Subject: Traffic Management Plan version 8

# Traffic Management Plan

## Menangle Sand and Soil Quarry

Prepared for Menangle Sand and Soil Pty Ltd  
June 2024

DRAWING TITLE:  
26m B-double swept path  
Site Access

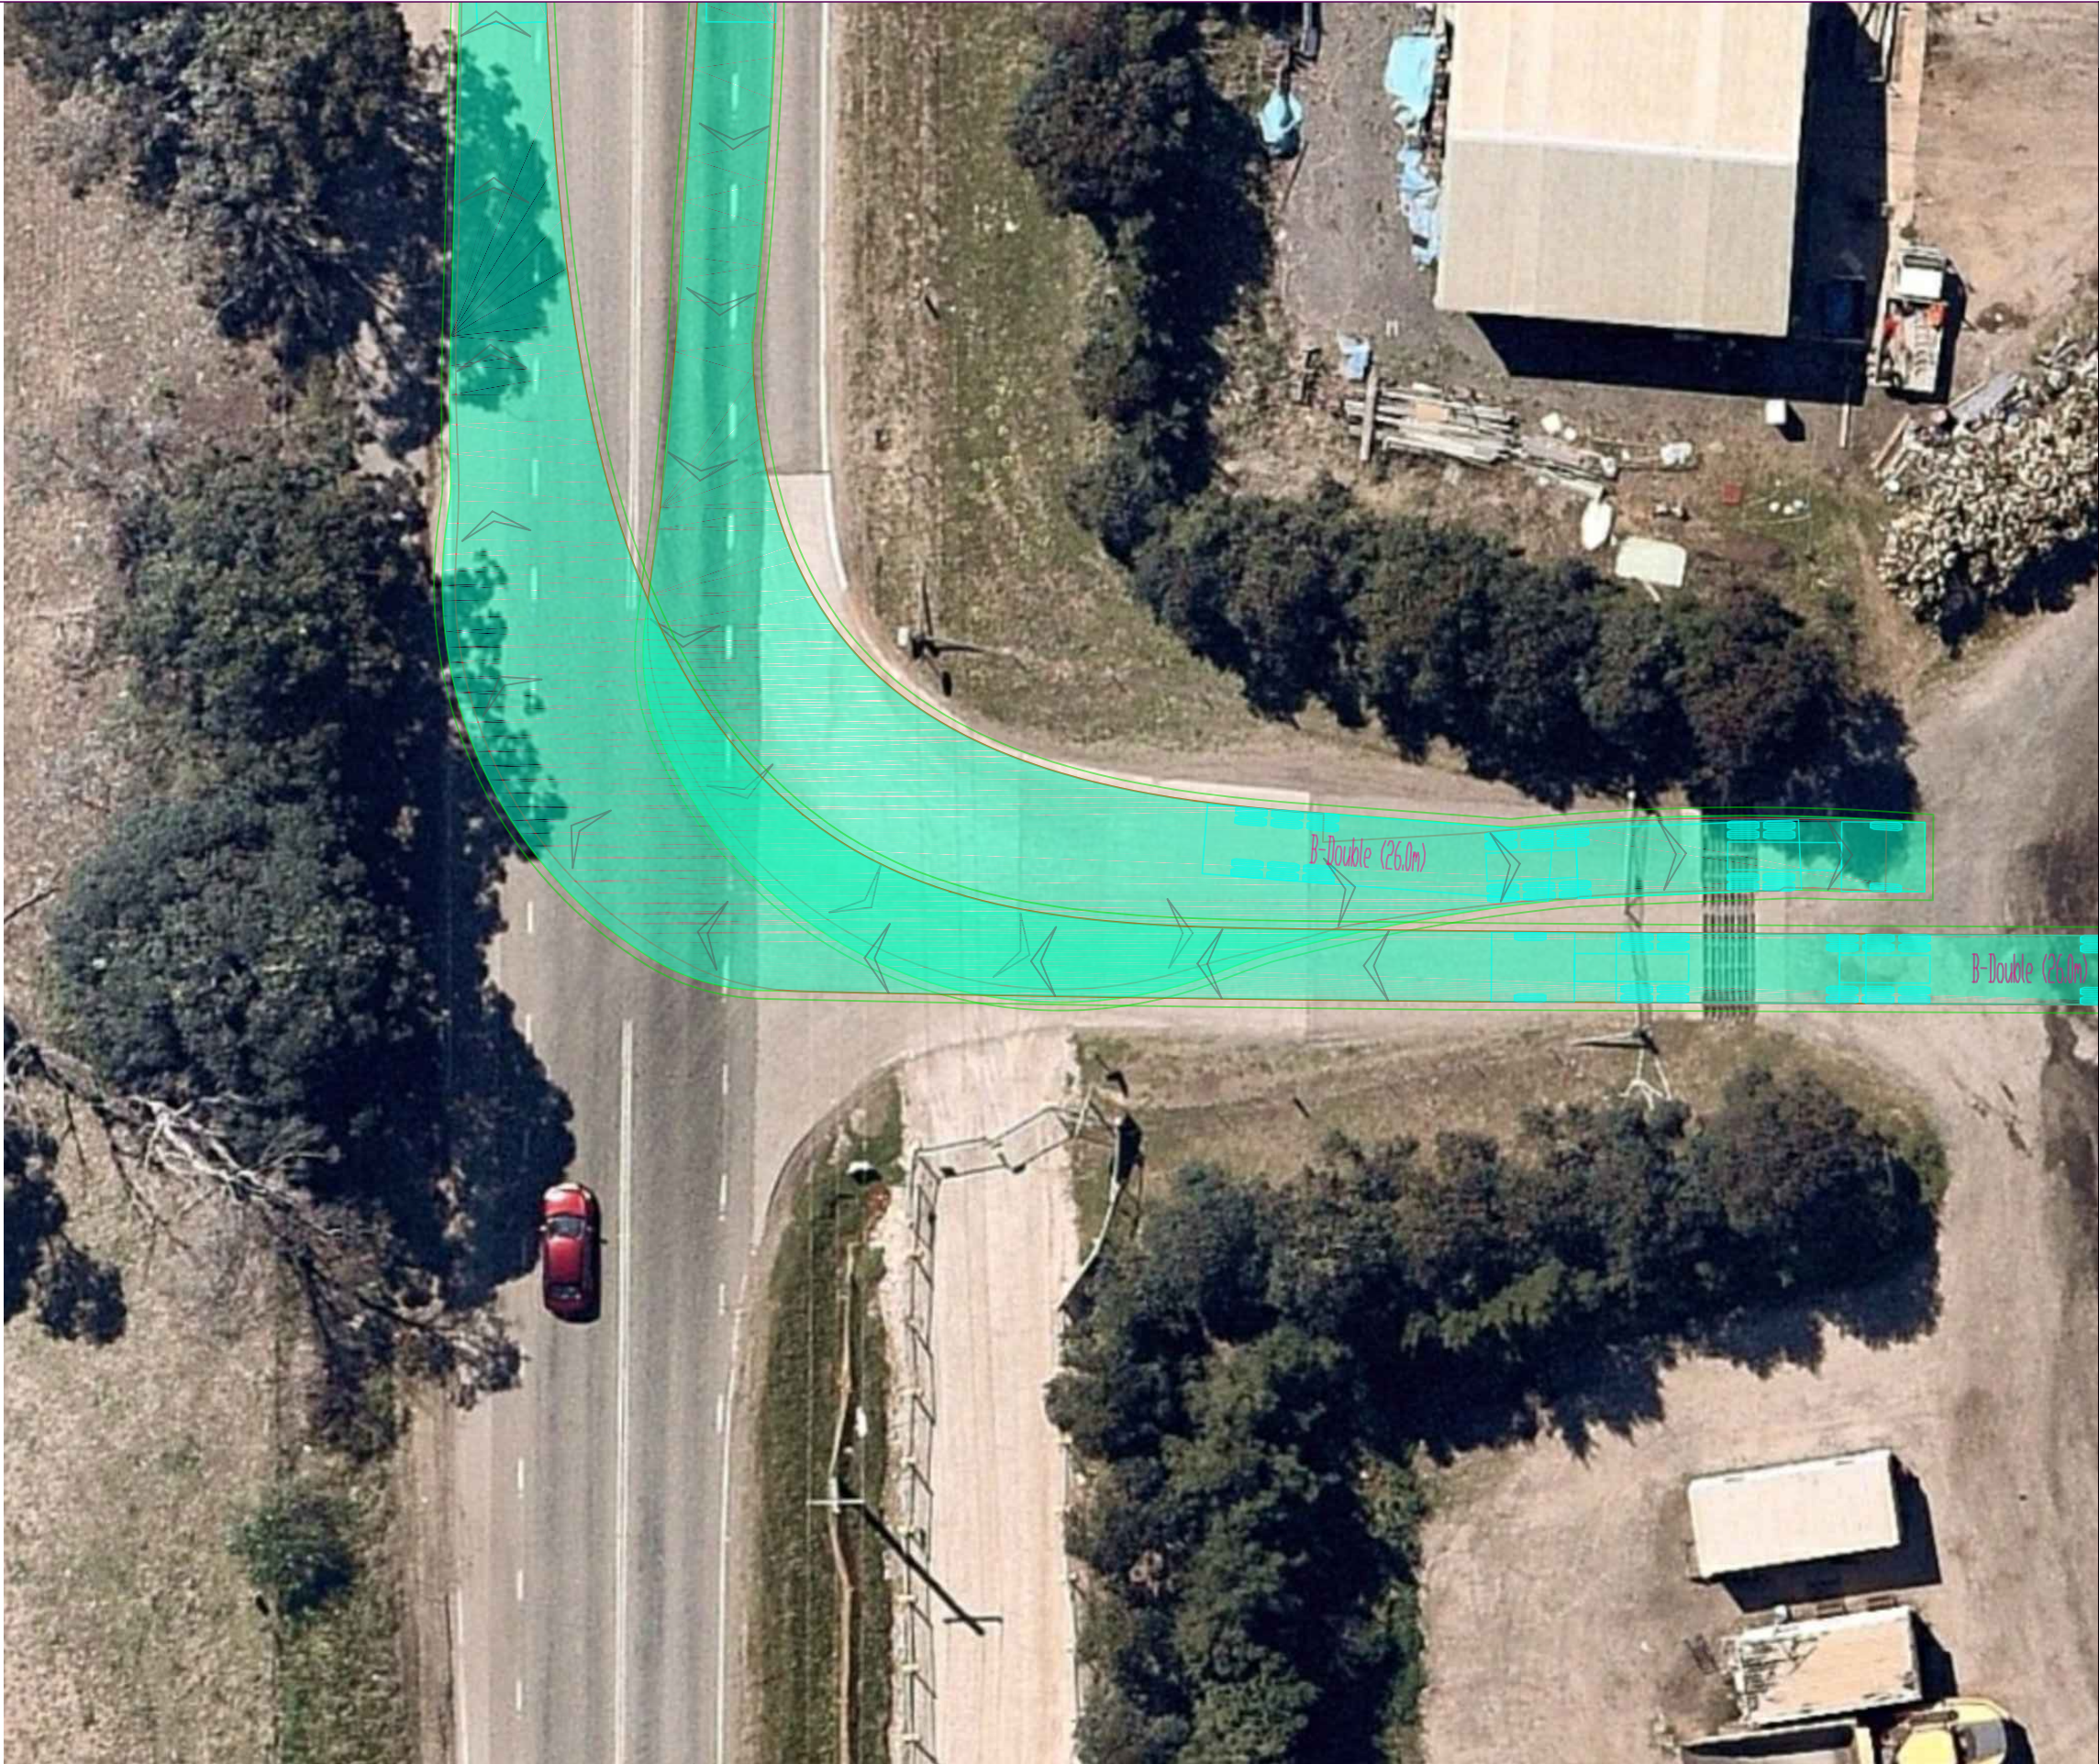
- The swept path plans provided in Appendix A show overlapping.
- Having regard to this, simultaneous entry and exit of B-doubles to the site should be avoided from Menangle Road.
- TfNSW has no further comments.

Thanks for your time and the TfNSW comments below. We will make a note of this in the management plan.
